POLICE SERVICE BULLETIN

PM-102

February 19, 1988

HIGH OUTPUT CHARGING SYSTEM

Figure 1. New Stator Plug

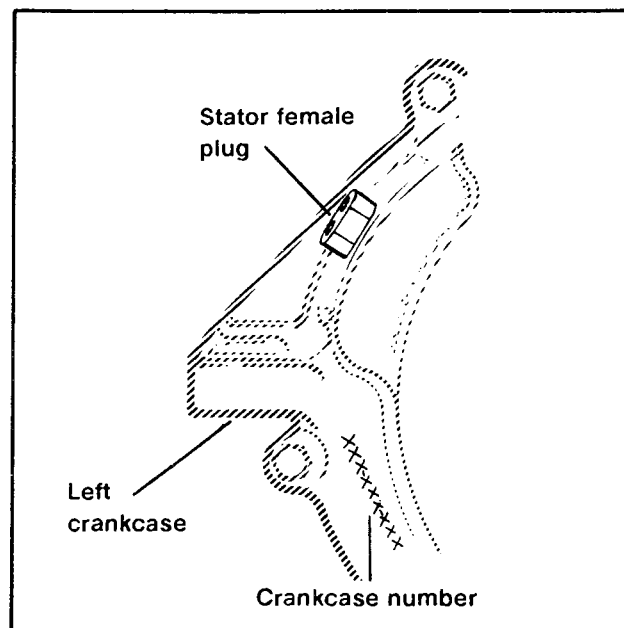
1. See Figure 1. With regulator male plug disconnected, the new stator female plug extends above the left crankcase surface as shown. This plug is below the crankcase surface on the old system. The center-to-center distance of the plug terminals and their diameter has been increased—this prevents connecting an old regulator to a new stator or a new regulator to an old stator.
2. The beginning Vehicle Identification Numbers (VIN) for Police motorcycles equipped with the high output charging system are:

Figure 2. Charging System

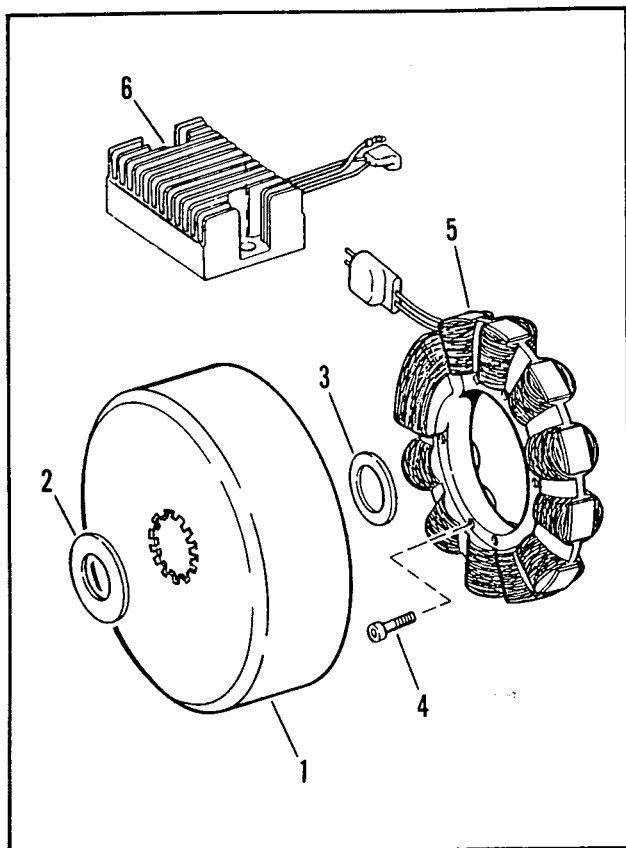
See Figure 2. If crankcase has been machined for new wider stator the spacers (2) and (3) must be installed as shown: i. e., thick spacer outside rotor and thin spacer inside rotor.

A high output alternator kit for 1980 and later "rubber-mount" motorcycles will be made available at a later date. Since the crankcases on earlier engines are not machined for the added stator width, the rotor will be shimmed outward 0.060 in. by placing the thick spacer (2), Figure 2, inside the rotor and the thin spacer (3) outside the rotor.

Figure 3. Left Crankcase Half

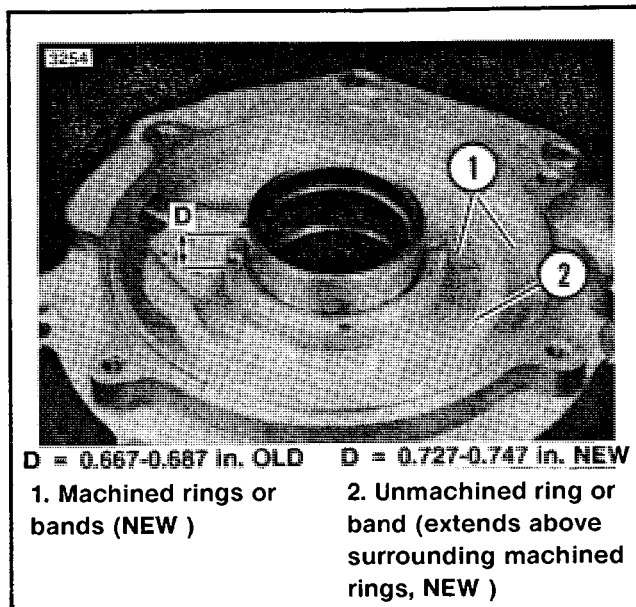
The new stator is 0.080 in. wider. To provide clearance between rotor and stator, the crankcase stator mounting surface has been machined 0.060 in. deeper. See Figure 3 for information on determining whether crankcase has been machined for new stator. The beginning crankcase numbers, machined for new stator, are as follows:
